<b>Office Action Summary</b>	<b>Application No.</b>	<b>Applicant(s)</b>	
	10/812,011	LIM, JEONG-SU	
	<b>Examiner</b>	<b>Art Unit</b>	
	Todd M. Epps	3632

This is the second Office Action for serial number 10/812,011, Monitor Apparatus, filed on March 30, 2004.

FIG. 1  
(PRIOR ART)

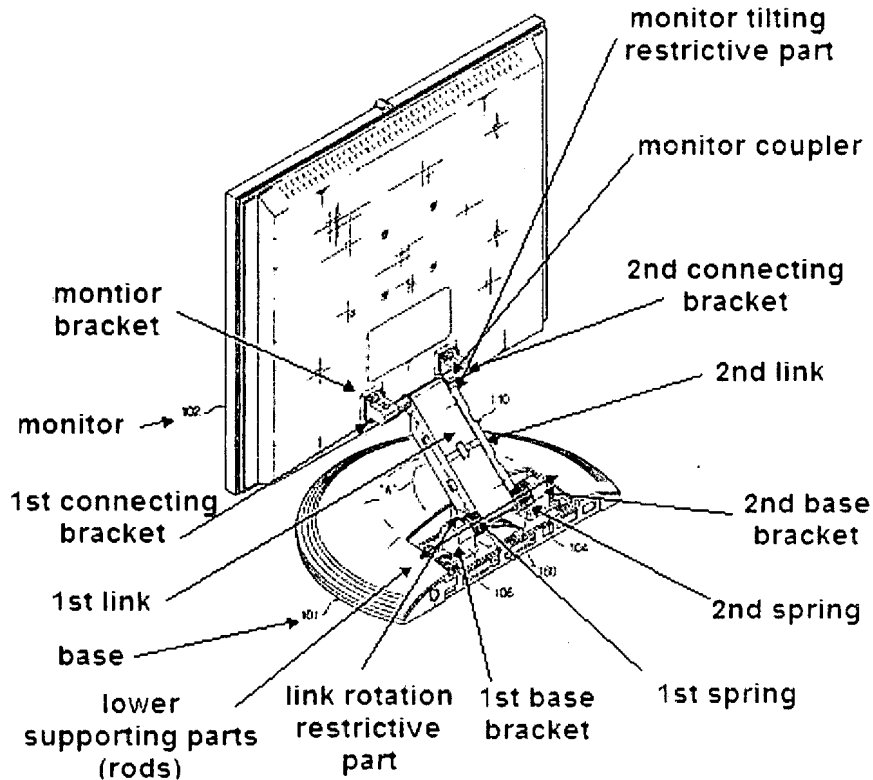
Claims 1-4, 6, 13, and 38 are rejected under 35 U.S.C. 102(b) as being anticipated by the Applicants Admitted Prior Art (AAPA) as identified by Fig. 1-2b of the drawings, and pages 1-2 of specification, which the applicant submitted.

The prior art discloses a first link (110, interior) provided between the monitor (102) and the base (101); a second link (110, exterior with H-shape) provided between the monitor (102) and the base (101), and adjacent to the first link; wherein the second link is provided as a pair (110, 2<sup>nd</sup> side - top portion and side portion) and formed to be bar-shaped; a base bracket (104, and 106), combined to the base (101), the base bracket having first and second lower supporting parts (adjacent of 104, and 106) to rotatably support lower parts of the first and second links, respectively; a connecting bracket (fig. 1) rotatably combined to the monitor (102), the connecting bracket having

first and second upper supporters (fig. 1) to rotatably support upper parts of the first and second links, respectively; a first spring (fig. 1- 1<sup>st</sup> side) interposed between the first link and the first lower supporting part, to elastically bias the first link upward with respect to the base; wherein the first spring comprises a torsion spring having a first end coupled to the first lower supporting part, and a second end coupled to the first link; wherein the monitor is tilted with respect to the connecting bracket to adjust a tilting angle of the monitor; a second spring (fig. 1- 2<sup>nd</sup> side) interposed between the second link and the second lower supporting part to elastically bias the second link upward with respect to the base, wherein the distance between rotating axes of the first and second lower supporting parts that rotatably support the first and second links, respectively, is greater than the distance between tilting axes of the first and second upper supporters; a monitor coupler (fig. 1) spaced from the first and second supporters, and rotatably combined to the monitor; a link rotation restrictive part (fig. 1; bottom between springs and links) to restrict a rotation angle of at least one of the first and second links relative to the base; wherein the link rotation restrictive part further comprises a protrusion protruding from the base bracket to restrict the rotation angle of at least one of the first and second links by making contact with an upper surface of at least one of the first and second links (fig. 1); wherein the second spring further comprises a torsion spring having a first end removably coupled to the second lower supporting part, and a second end removably coupled to the second link; a monitor bracket (fig. 1 - backside of the monitor) combined to the monitor, and rotatably combined to the connecting bracket;
